RE: SUBMISSION TO DA2021/1790 – 214 HUDSON PARADE
CLAREVILLE.

My firm has been commissioned by Mr. M and Ms. G Guberina, owners of 216 Hudson Parade Clareville to prepare this submission to the Proposed Development Notification correspondence dated 14 October 2021 received. This notification advises that development application, DA2021/1790, has been lodged, that seeks consent for proposed alterations and additions to the existing dwelling house that also will include installation of a swimming pool and garage at 214 Hudson Street Clareville. 214 Hudson Parade Clareville is the neighbouring property to the west of my clients' property.

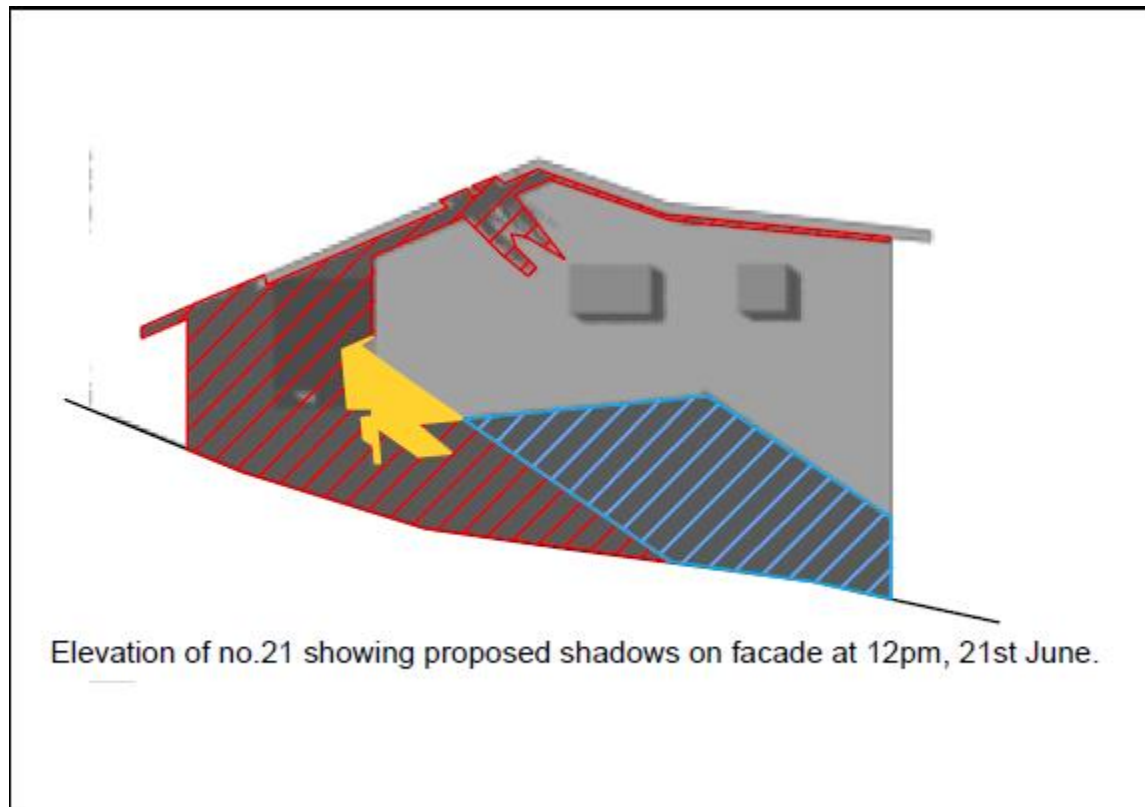
12pm

The shadowing drawing identifies there is to be an overshadowing increase will cover

the lower section of the building as indicated by the blue cross hatching on the drawing extract as follows, with a slight solar increase as indicated by the yellow colour.

The increase in overshadowing will reduce solar access for the lower level of the building and the solar heating obtained of the lower level that will also indirectly heat the upper level of the house through the rising of heat from this lower level.

The outcome of this decrease in access to solar heating, will therefore generate a greater use of heating in winter to maintain the same level of internal comfort in both the lower and upper levels.

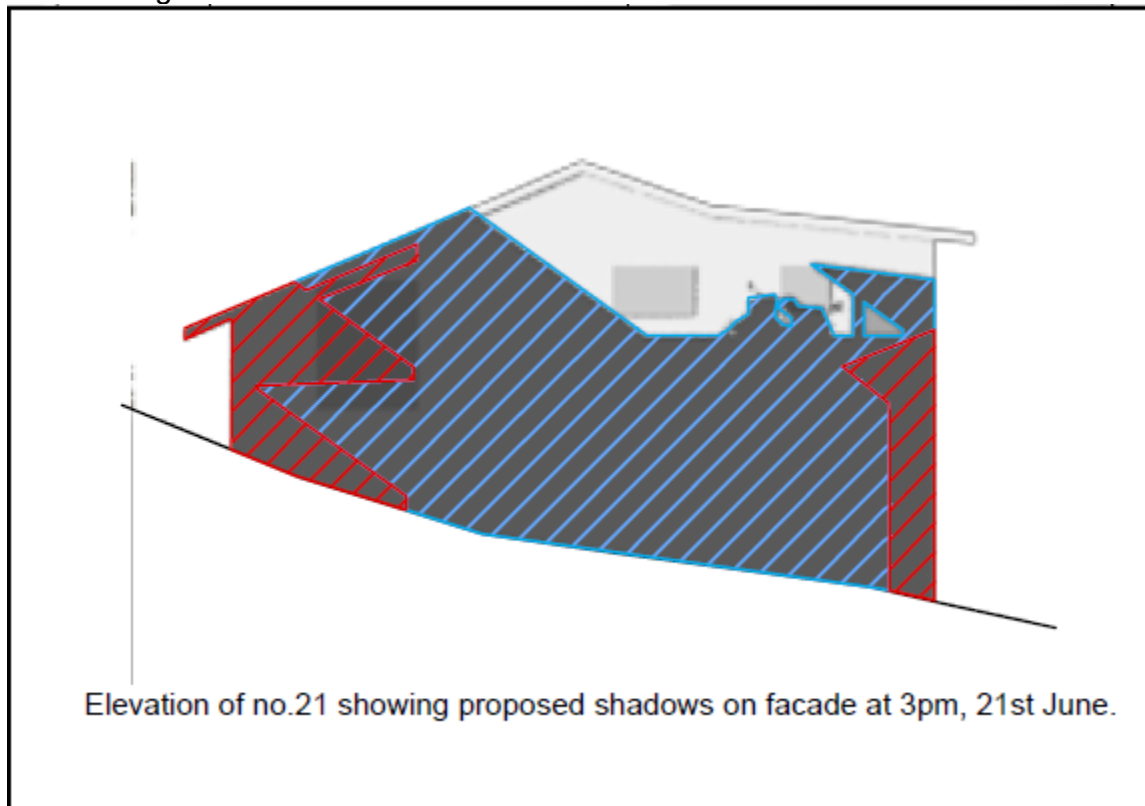
3pm

The shadowing drawing identifies there is to be an overshadowing increase that will cover a substantial amount of the building as indicated by the blue cross hatching on

the drawing extract as follows.

The overshadowing increase identified in the above diagram will result in a substantially greater reduction in solar access to that already identified in the 12pm response.

The amount of overshadowing increase at 3pm will have a substantially greater internally cooling effect on the internal winter comfort level to both the upper and lower levels there is to be no access to the solar heating to both levels as with the current situation.

The resultant outcome will be, as indicated in 12pm response above, that this situation will result in a need for greater internal heating of both levels than required currently to maintain the current level of internal winter comfort. Accordingly, this situation will result in a substantial detrimental result for both my clients' and the environment due to an increase in potential global warming through more generation of greenhouse gases.
